From: [nadene thorne](mailto:nadene.thorne)
To: manu.koenig@santacruzcounty.us; thekristenbrown@gmail.com; s.brown@cityofsantacruz.com; apedersen@ci.capitola.ca.us; vanessa.quieroz@cityofwatsonville.org; eduardo.montesino@cityofwatsonville.org; felipe.hernandez@santacruzcounty.us; justin.cummings@santacruzcounty.us; bruce.mcperson@santacruzcounty.us; zach.friend@santacruzcounty.us; rj12@comcast.net; openup@ucsc.edu; [Regional Transportation Commission](#)
Subject: Segment 9, Rail Trail EIR
Date: Tuesday, May 2, 2023 8:12:02 PM

Subject: Request to Address Environmental Impact of Entire Rail-Trail Project, 5-2-2023

Using SUPLOS Calculator Segment 9 grades F F E F

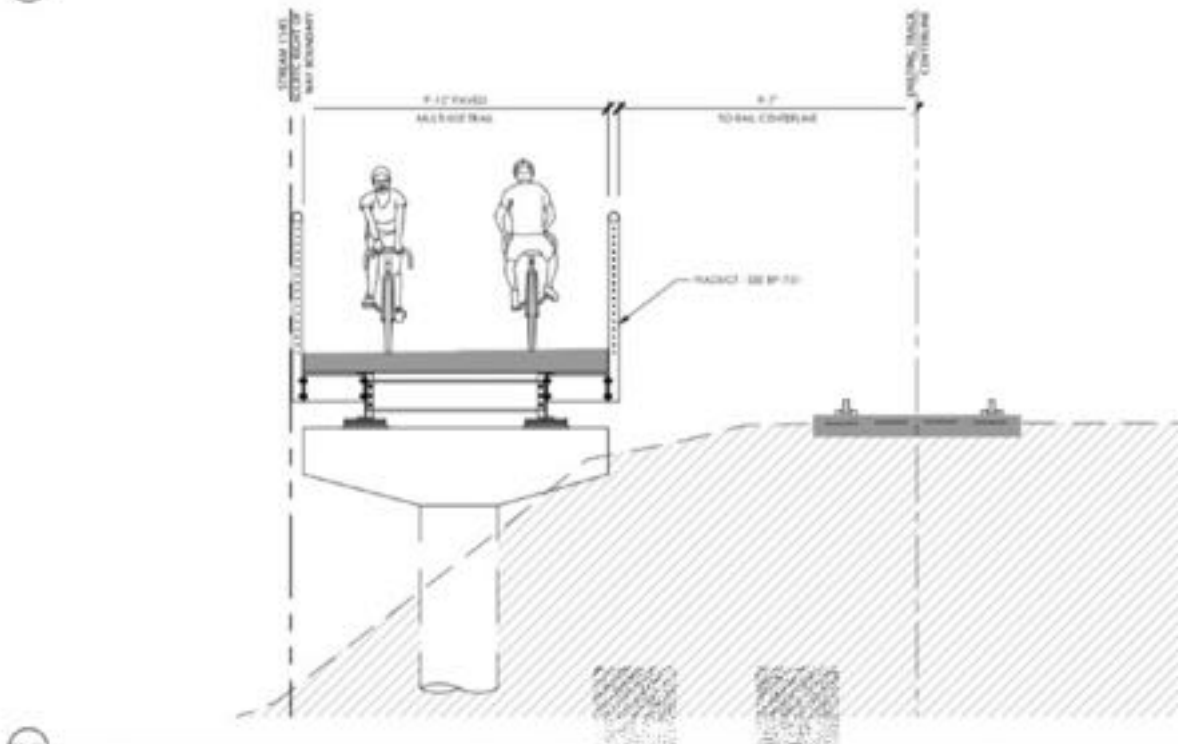
The EIR describes Segment 9 as "a 12-foot trail inclusive of shoulders" with LOS grades of C, D and E. However, using 8 feet as width in the SUPLOS calculator, scores are mostly F "significant user conflicts should be expected." (5) A trail perceived to be unsafe will discourage use by the most vulnerable users: children, elderly and those with disabilities.

Width 8'

Users 187-276 each direction (per project manager)

Mode split % of bikes/peds 68/27 and 76/19 (per project manager)
